Bulletin No.: 245_V_4_63_Software_Release

OfficeServ 7100 & 7200-S Software Version 4.63 General Availability

Samsung is pleased to announce the release of version V4.63 system software for OfficeServ 7100 and 7200S systems.

U100 & U200 are
labeled V1.4

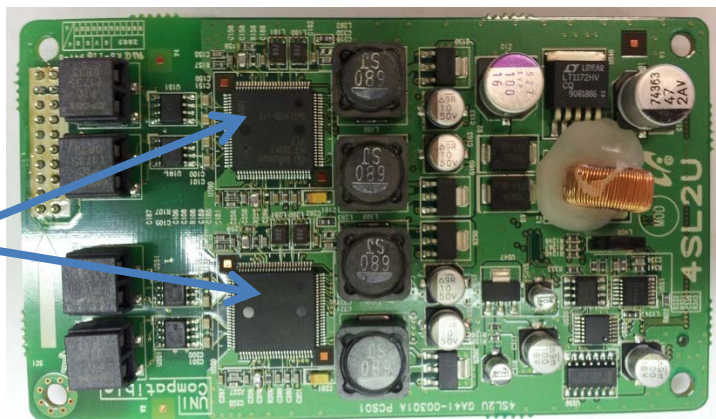
V4.63 system software is required to support the 4SL2U V1.4 daughterboard to be released on a running change basis later this year. The U100 & U200 chips on V1.3 4SL2U were discontinued. A new version chip is used on V1.4 4SL2U card. Functionality is exactly the same.

Supports new 4SL2U (V1.4) Daughterboard
